February 28, 2017
BOARD OF COUNTY COMMISSIONERS
ORANGE COUNTY, FLORIDA
Y17-731-CC / ADDENDUM # 3
WITTENSTEIN COTTAGE ADA UPGRADES AND RENOVATIONS
Bid Opening Date: March 7, 2017

This addendum is hereby incorporated into the bid documents of the project referenced above. The following items are clarifications, corrections, additions, deletions and/or revisions to and shall take precedence over the original documents. Underlining indicates additions, deletions are indicated by ~~strike through~~.

File Name
X:\dwgs\15253 OC Wittenstein House ADA\CAD\SHEETS\
A05.01 FINISH FLOOR PLAN.dwg

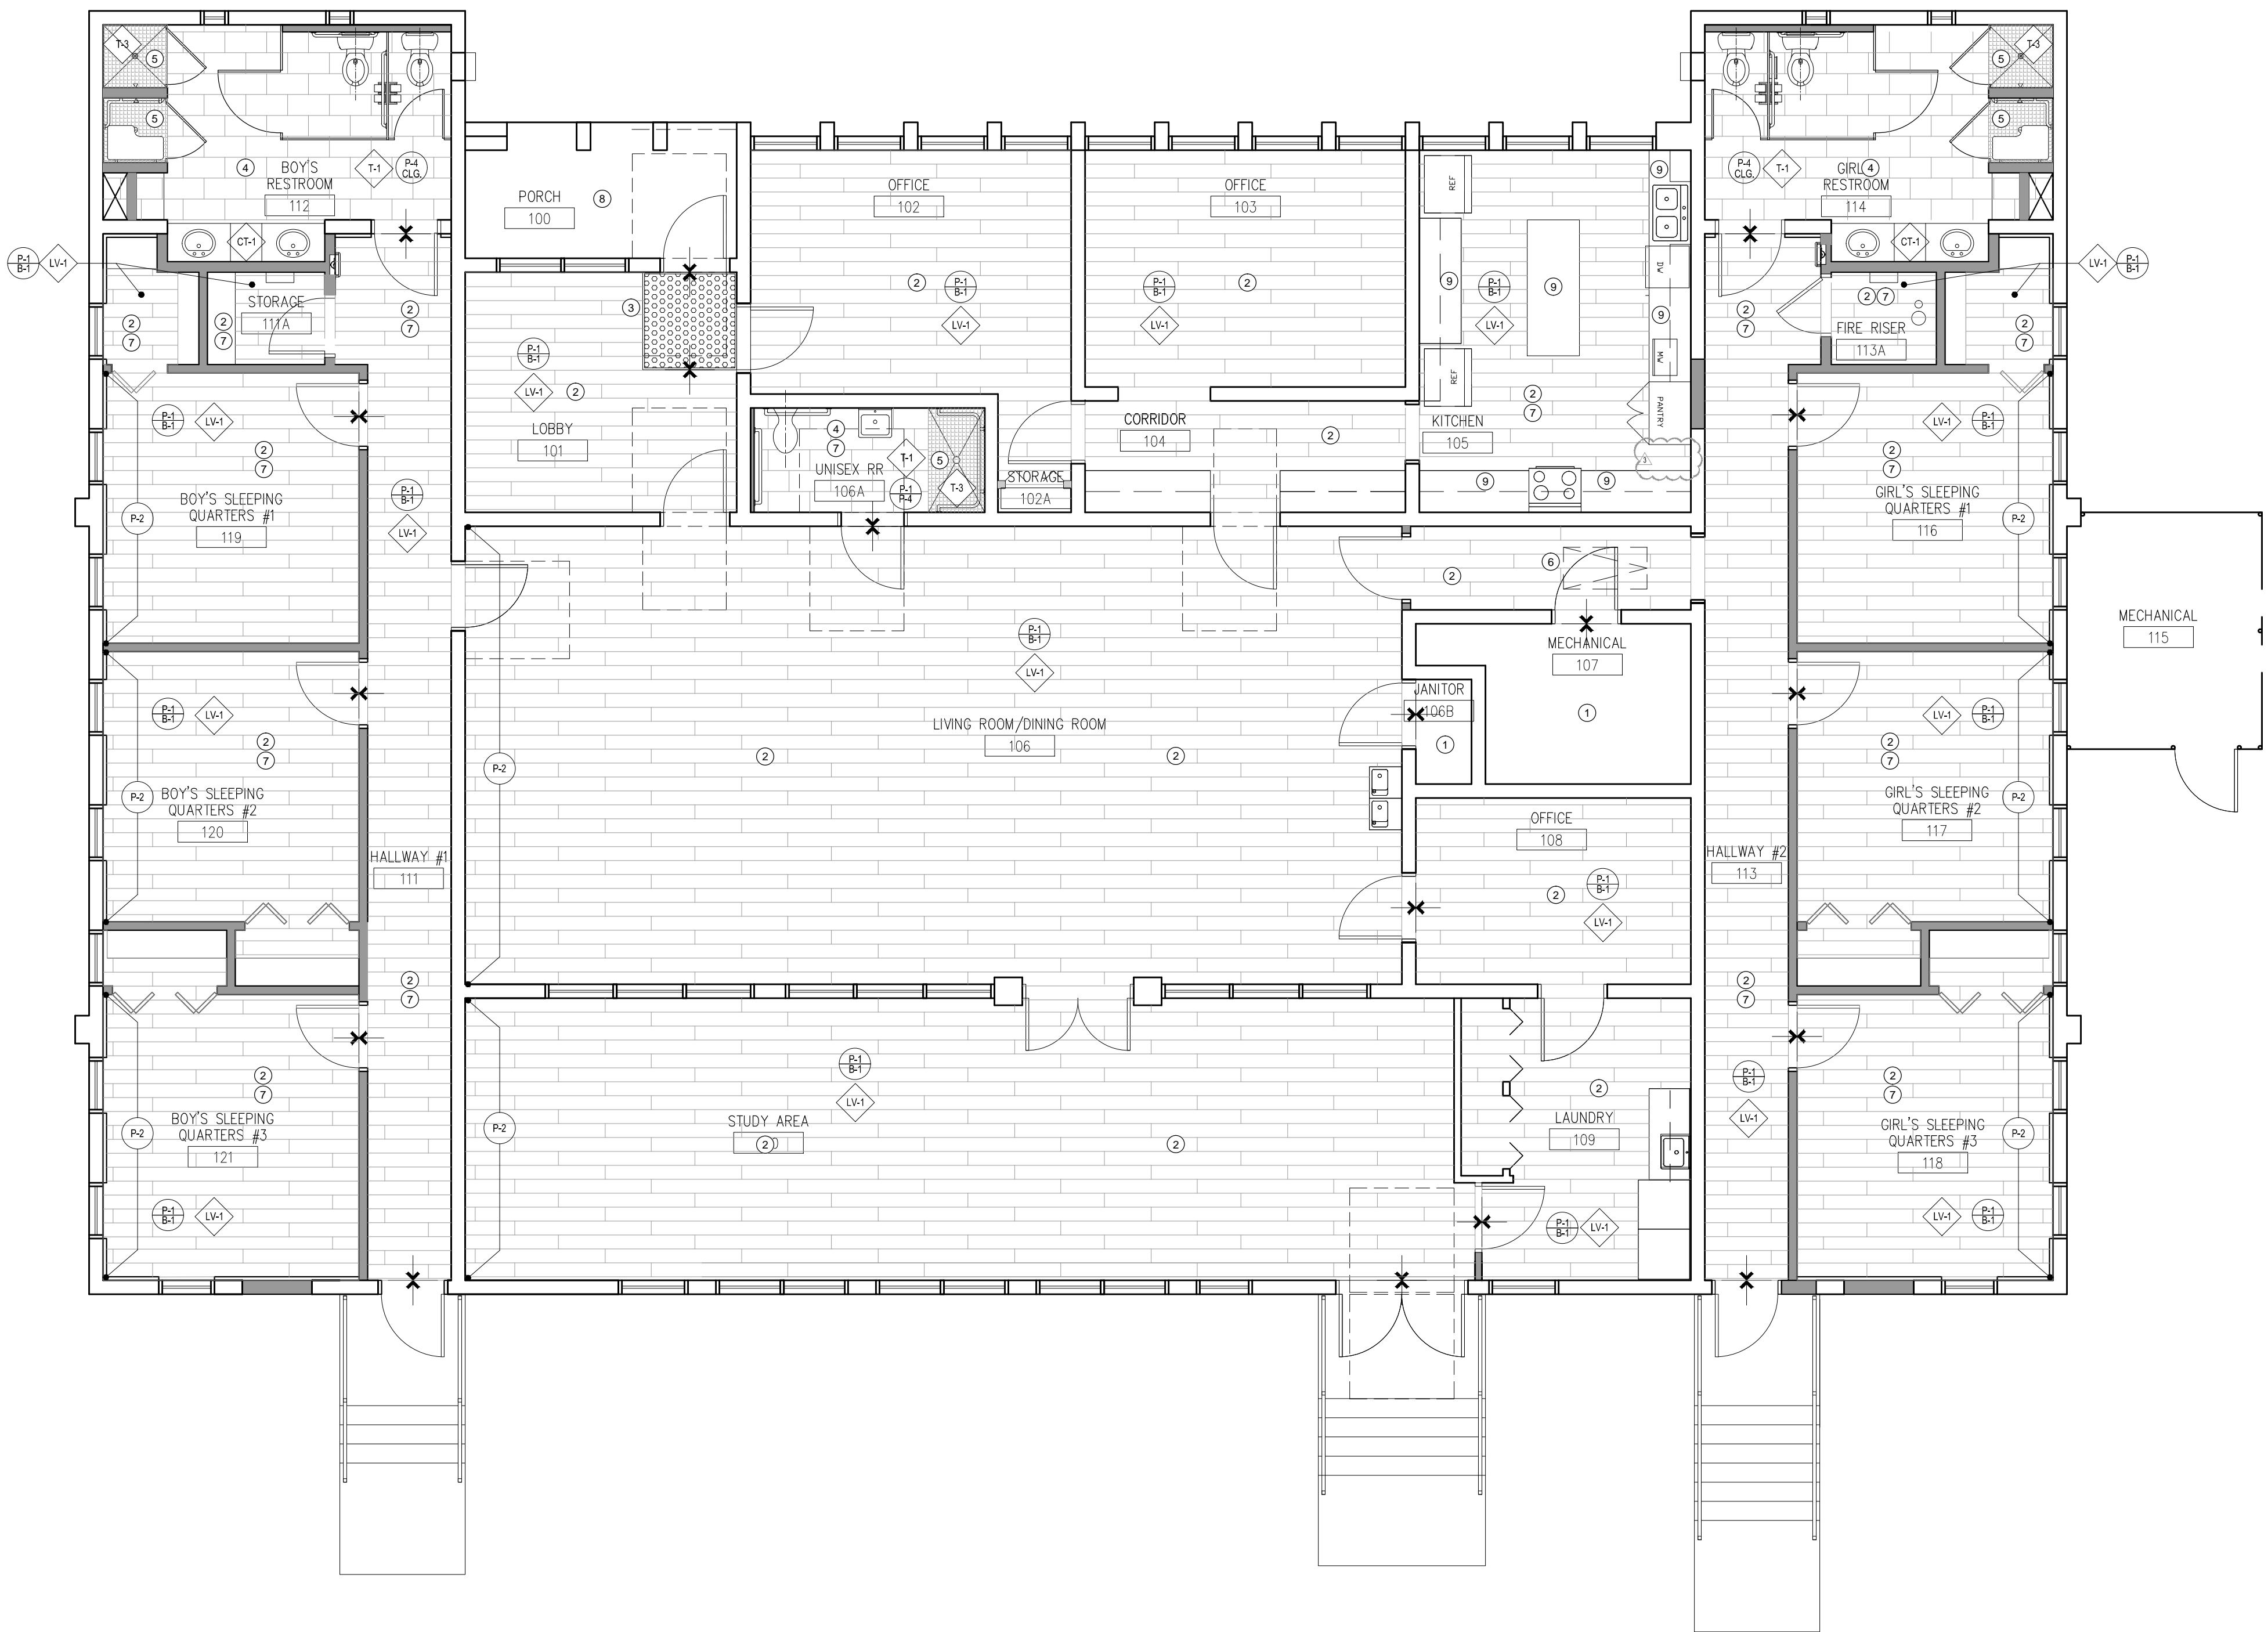
16. Question: I did not see what kind of finish for the countertops for both the kitchen and the laundry room?

Answer: The drawings call for plastic laminate to match existing. The Additive Bid Pricing should be for solid surface material, as shown on finish tag CT-2, on attached sheet A05.01.

Sheet Title:
FURNITURE & EQUIPMENT LAYOUT

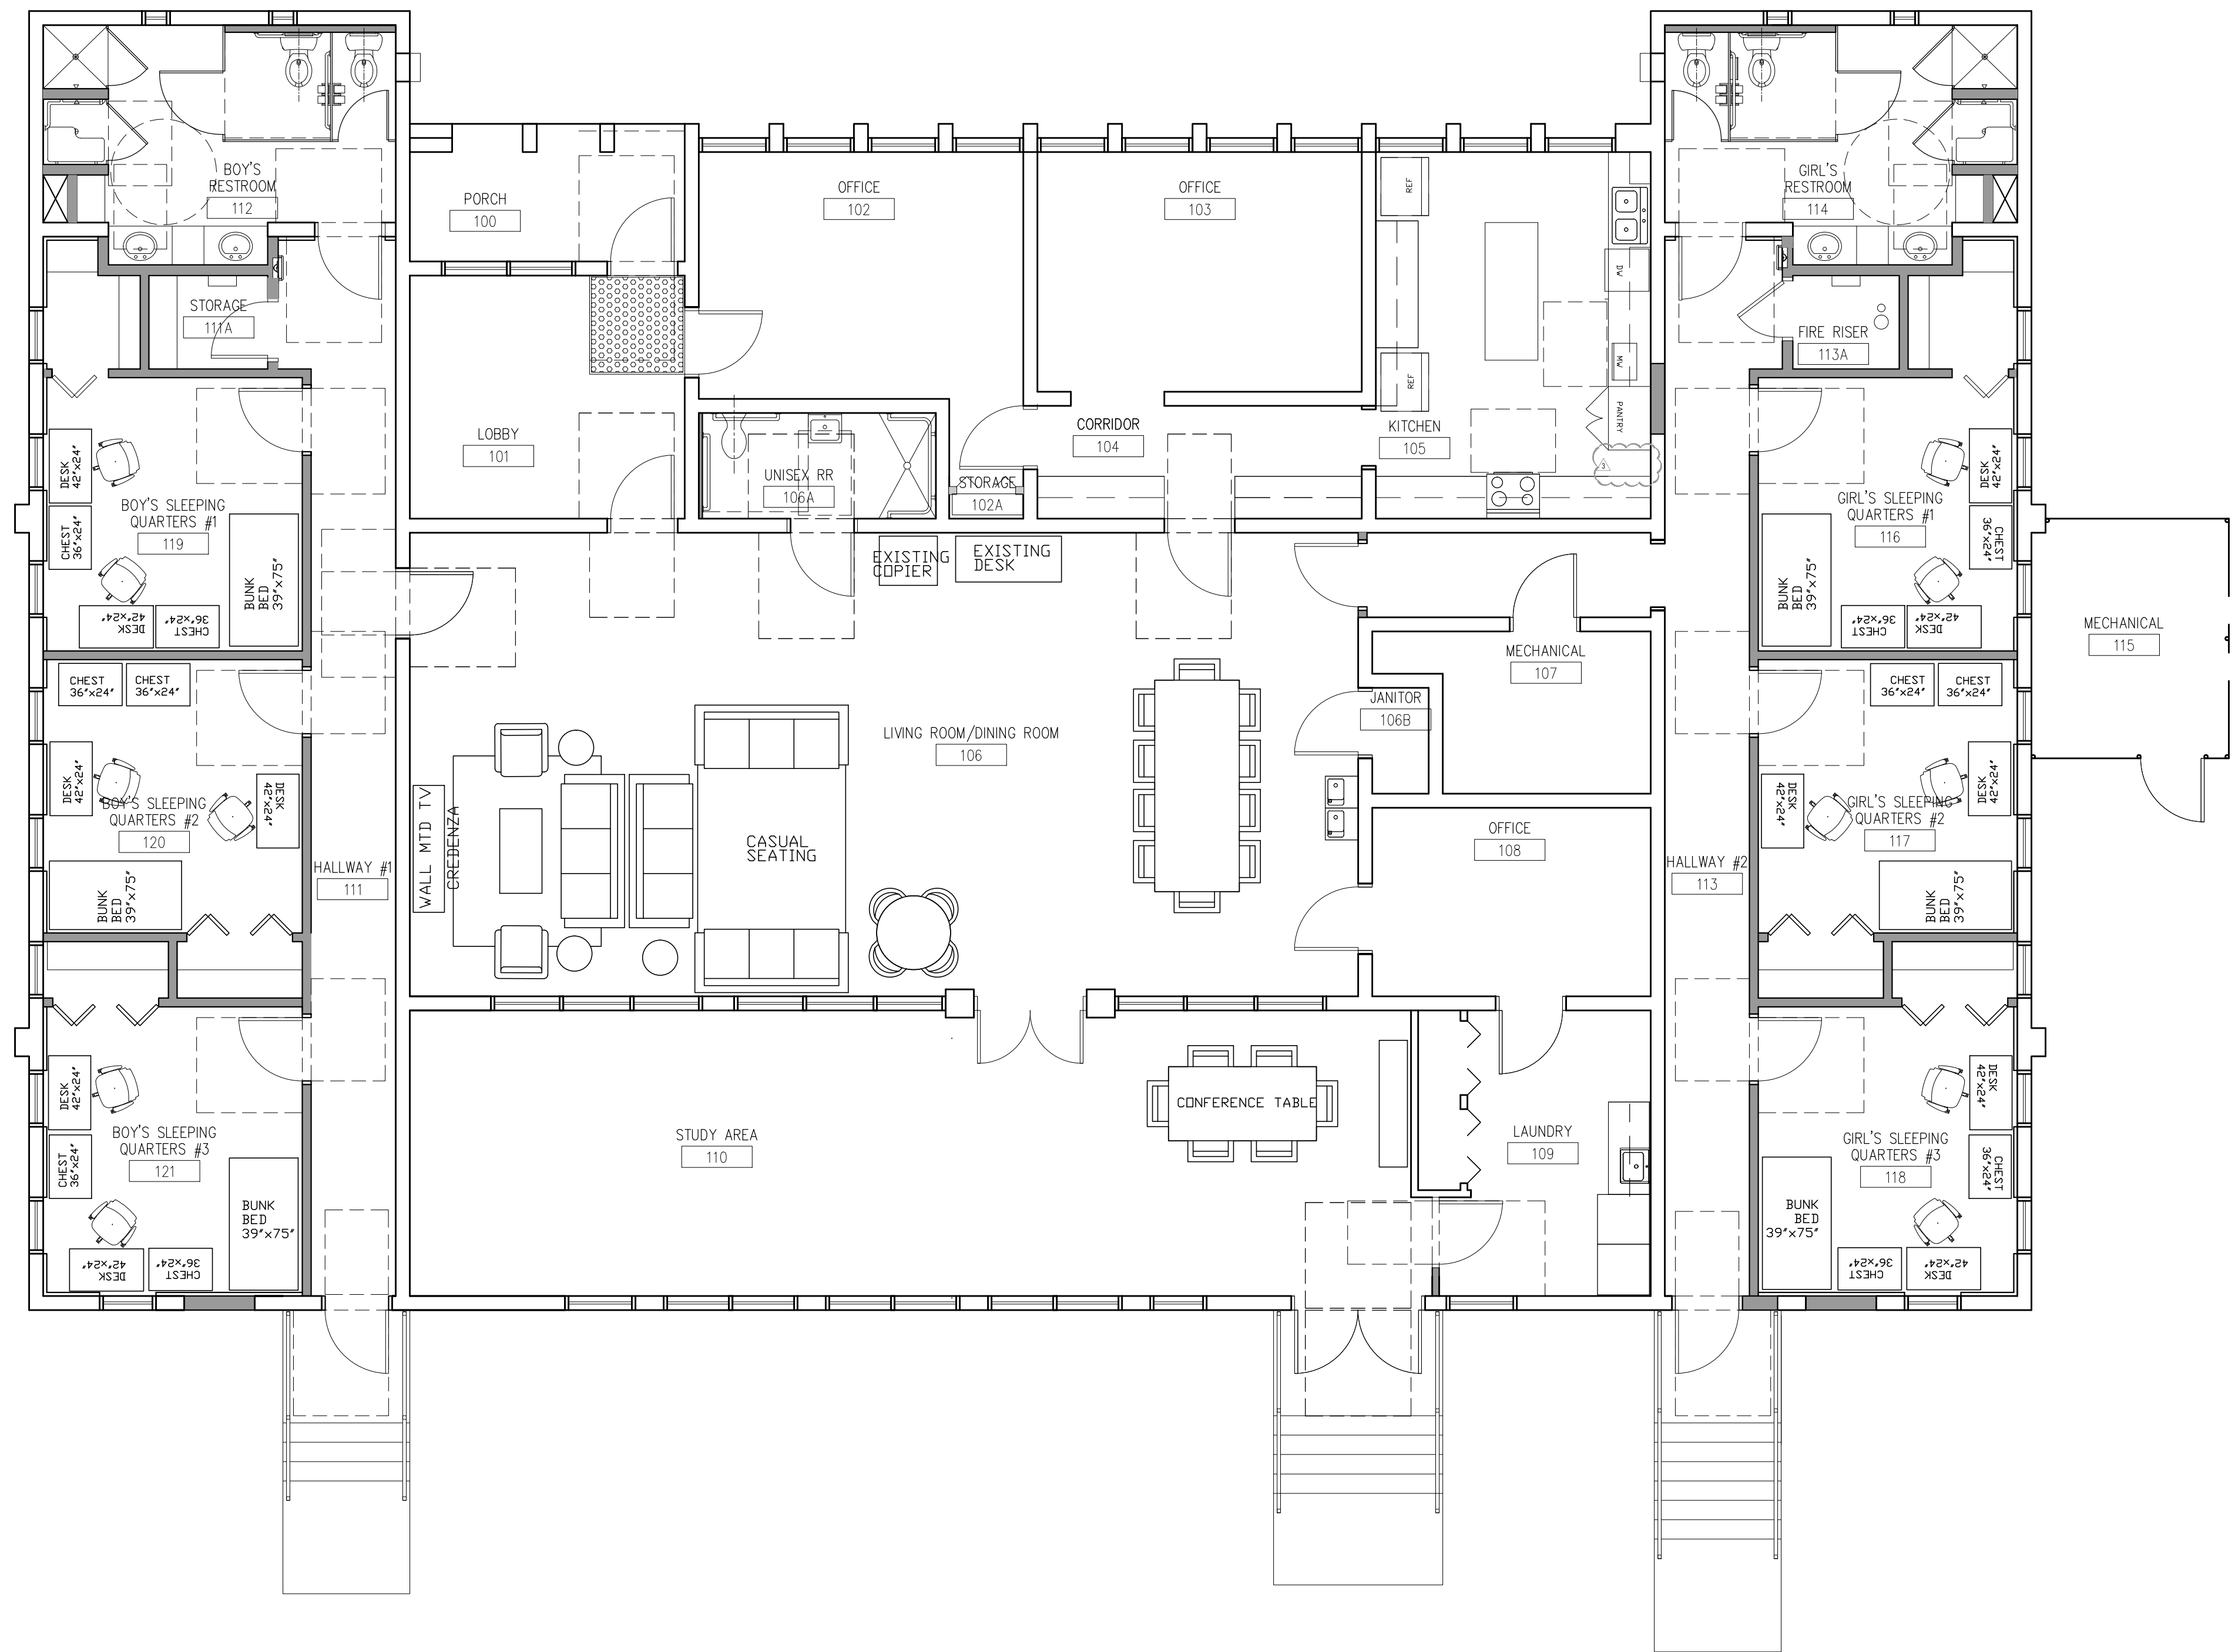
2. Question: Can the County provide a list of the furniture/equipment to be deep cleaned as indicated on A 6.01?

Answer: A list of furniture/equipment for deep cleaning is not available. Provide cleaning as needed once construction is complete. See attached revised sheet note C on revised plan sheet A06.01.
